COMMENT TO THE STB BY MICHAEL A. TRUJILLO 1/17/2010
ENTERED
Office of Proceedings

28 West 5th Avenue, Antonito, Colorado

Bearing Points Trussed Bridge Over Conejos River

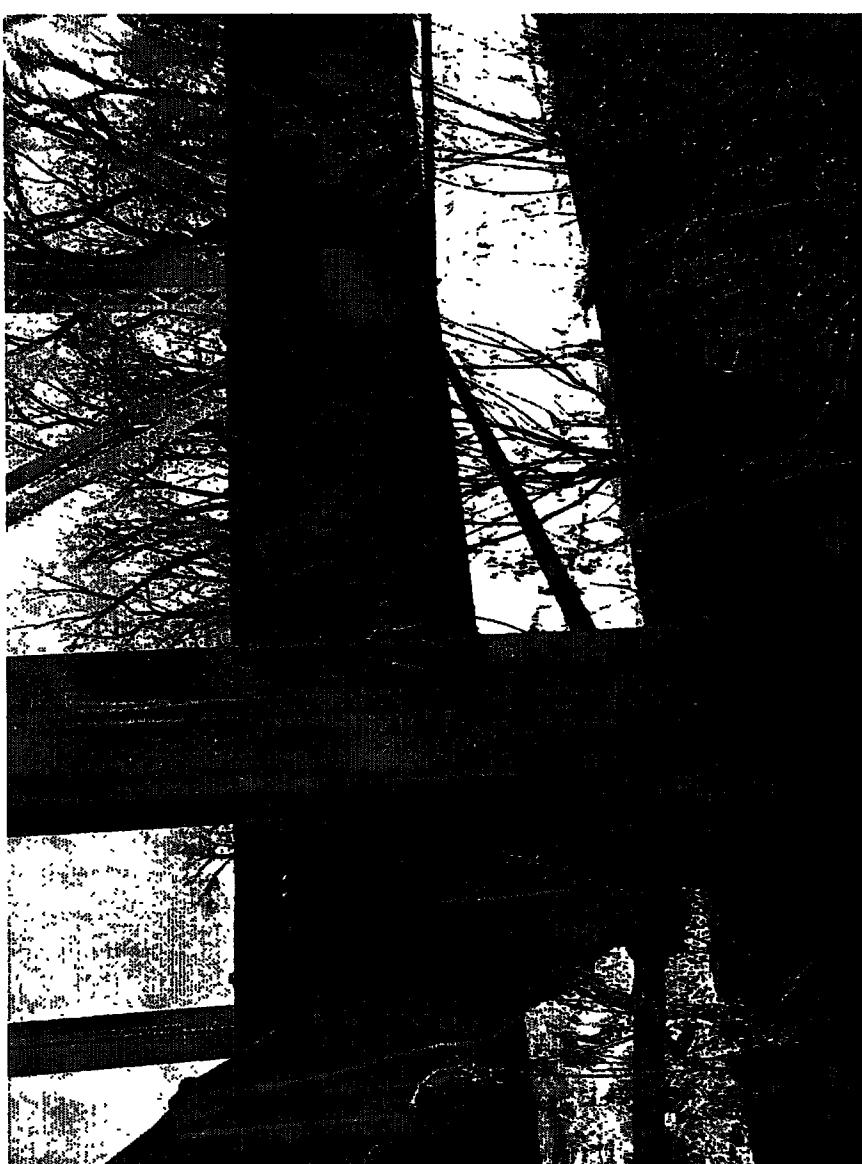
This photo reveals the bearing point of the north end of RR bridge . A retaining wall type scenarios presented here with Basalt Rock appearing to bear much of he weight. Separations are noted throughout, due possibly to age, expansion, and contraction. Stress fractures noted.

30" x 10" riveted steel girder system shows an abundance of oxidation. Several racking metal framing components in place are designed to move and appear to be locked. No literature exists to suggest that this particular bridge was ever inspected by any authority and carries no loading capacity.

Photo near duplicate of the previous reflecting ice building up at each end of the support system and reflecting water pressure points acting on support system when water is flowing.

This photo suggests that the weight of the bridge carries over to pads of basalt. Adjacent to the basalt and the horizontal "I" beam member, a significant 'expansion' area is noted. The question is, how much settlement has occurred throughout the years, and what is the soil bearing underneath?

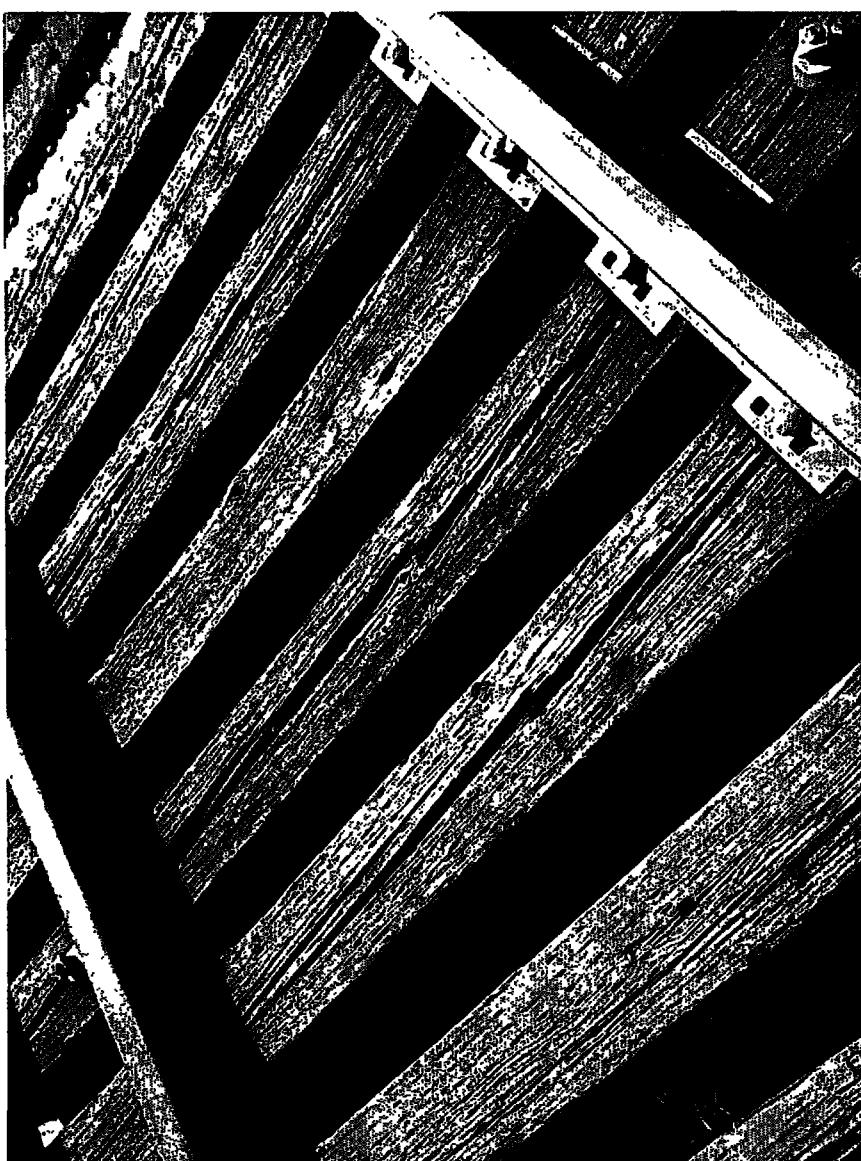
This photo notes web members that are bent revealing possible racking stress points. Note that there has been very little or no maintenance at all in terms of sanding, priming, and painting.

Top of RR Trussed Bridge over the Conejos River reflects various rail ties which could stand to be replaced. Note that one spike on each tie plate anchors the rail to the RR tie. Many instances suggest that the spikes may not have been slightly under-bored in order to prevent the tracks shown in the photo.

A series of railroad ties indicate approximately 8" spacing, thereby exposing the Conejos River to any material which may 'drop through'.

Here a 'catwalk' adjacent to a ledger (the outer perimeter of the bridge edges, which run perpendicular to the railroad ties) show bolts, which serve as structural fasteners, and possible create an adverse situation. Future maintenance would require the disassociation of fasteners from timber and railroad tie members, thereby making for a tedious process. This photo suggests some structural defects, most notably cracks in the ties.

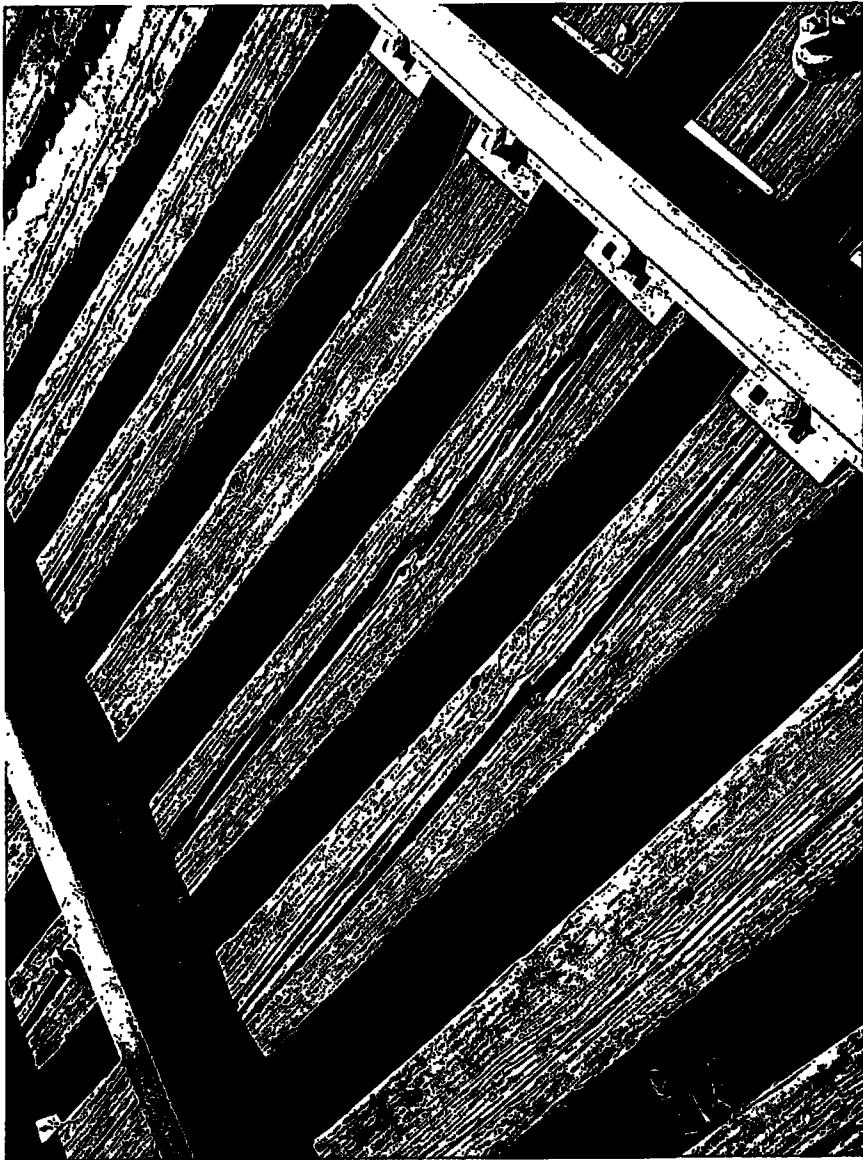
This photo notes web members that are bent revealing possible racking stress points. Note that there has been very little or no maintenance at all in terms of sanding, priming, and painting.

Top of RR Trussed Bridge over the Conejos River reflects various rail ties which could stand to be replaced. Note that one spike on each tie plate anchors the rail to the RR tie. Many instances suggest that the spikes may not have been slightly under-bored in order to prevent the tracks shown in the photo.

A series of railroad ties indicate approximately 8" spacing, thereby exposing the Conejos River to any material which may 'drop through'.

Here a 'catwalk' adjacent to a ledger (the outer perimeter of the bridge edges, which run perpendicular to the railroad ties) show bolts, which serve as structural fasteners, and possible create an adverse situation. Future maintenance would require the disassociation of fasteners from timber and railroad tie members, thereby making for a tedious process. This photo suggests some structural defects, most notably cracks in the ties.

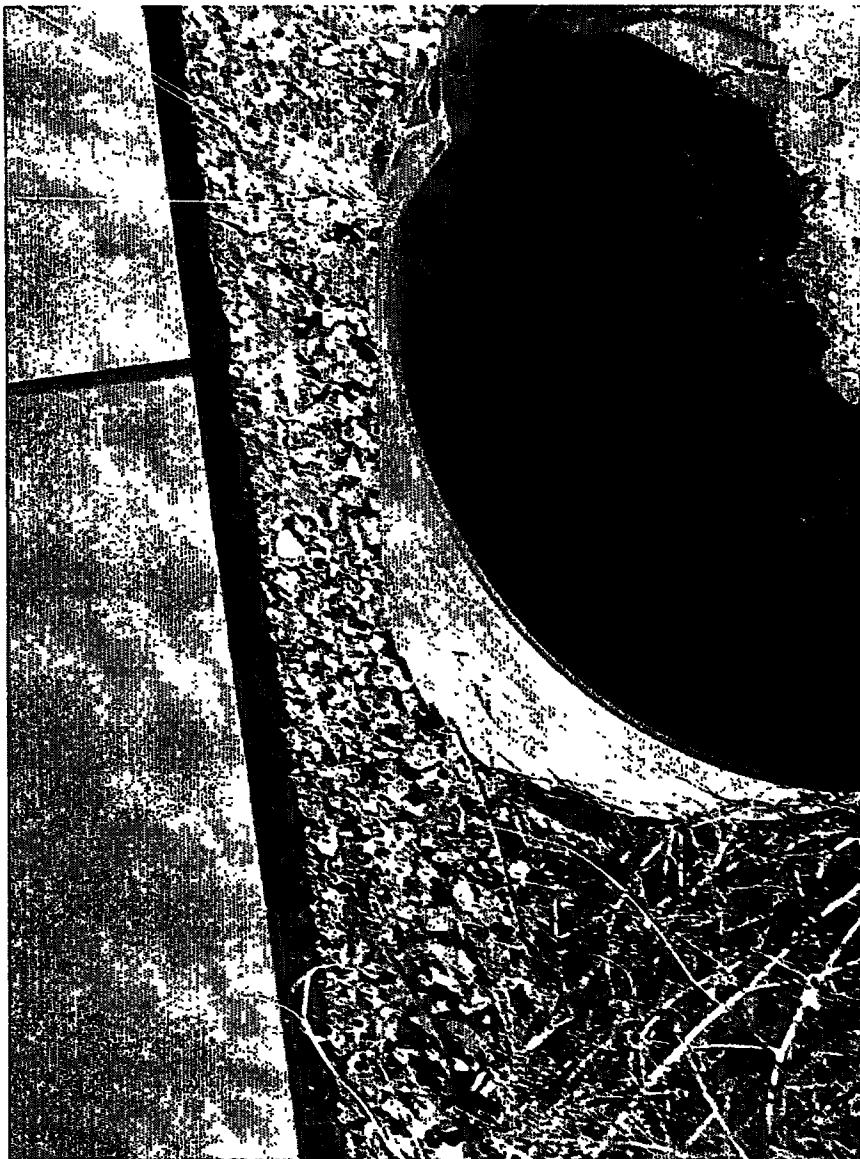
San Antonio Bridge, at the track top, reflects various railroad ties which obviously have to be replaced.

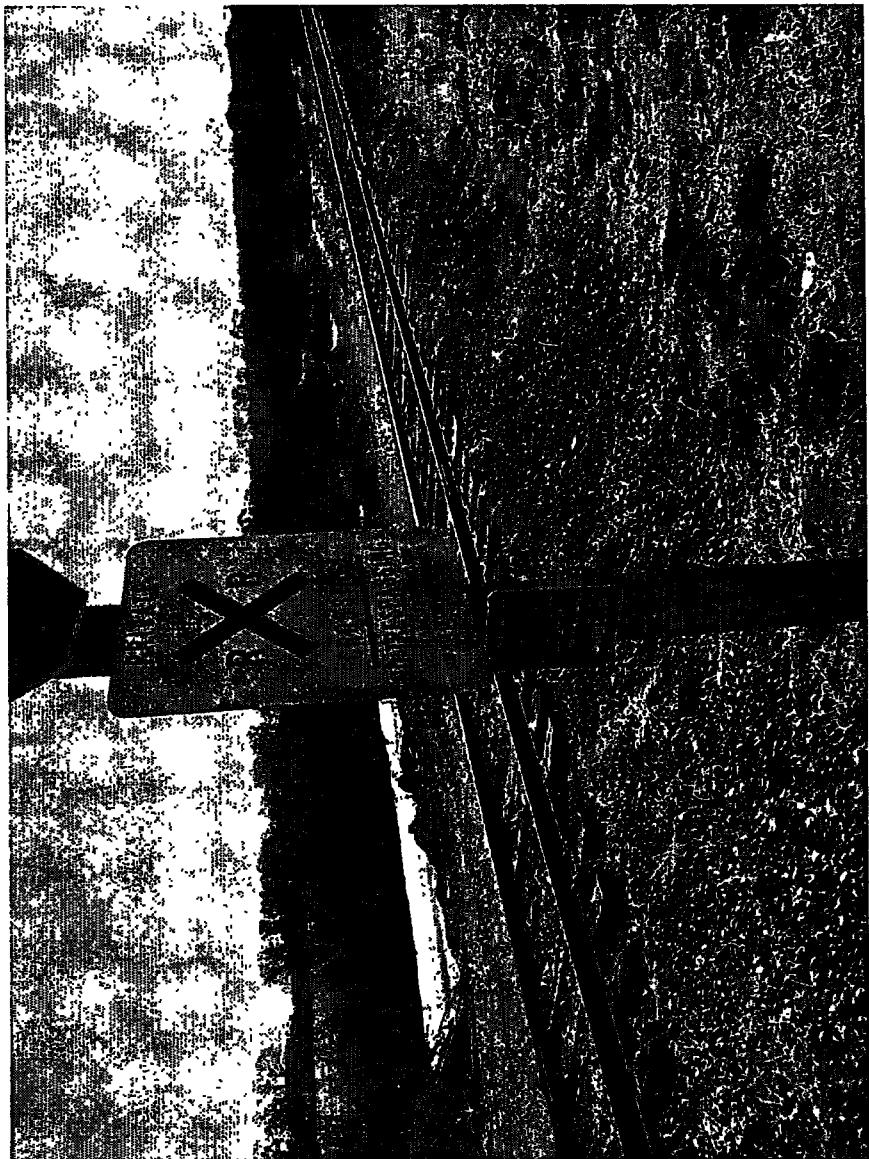
Bearing here is N37°39' W106 degrees00'39". Colorado Highway 285 is approximately 300 yards to the West and Conejos County Road G.5 is approximately 500 yards to the south. While the work is recent and 'new' much of the construction material is used and old. No indication of loading is to be found anywhere in the vicinity. Despite the 'new' work, at least two RR ties in this photo show severe stress breaks.

Still part of the renovation site. This photo suggests that the retaining walls deviate from the vertical. While this is possibly a loading design, it must be questioned then what the design criteria is—what is it? This is possibly a storm water discharge culvert. Precariously placed on Creosote treated timbers, very little regard given to the fact that the timbers are used and will obviously be submerged in water this coming spring.

Again precariously placed storm water discharge culvert. Little regard given to the fact that these Creosote treated timbers will obviously be submerged in water this coming spring. In the meantime note that the walls and support systems deviate from the vertical. Metal stacks are expected to stabilize horizontally placed timbers which possibly act as a retaining wall to shore up existing disturbed soil and some ballast material.

Metal stacks are expected to stabilize horizontally placed timbers which possibly act as a retaining wall to shore up existing disturbed soil and some ballast material.
